U.S. DEPARTMENT OF
ENERGY

Office of Project Assessment
pre-CD-2 Review Report on the

**High Luminosity LHC
U.S. ATLAS Detector Upgrade
(HL-LHC ATLAS) Project
at Brookhaven National Laboratory**

January 2022

Figure 3-1. Overlapping Critical Paths

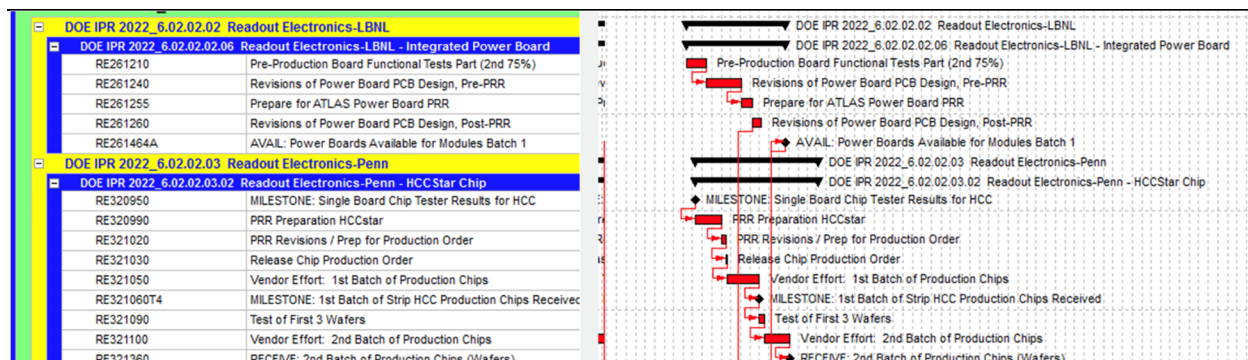
The project presented a resource loaded schedule with constraints and with unclear critical paths. For example, the strips WBS has overlapping critical paths (Figure 3-1). After January 2023, a driving critical path is clear.

Schedule quality tools, e.g., Acumen Fuse (used by project) and/or the Government Accounting Office (GAO) best practice checklist for cost estimating and scheduling may aid in improving product quality before baselining the project.
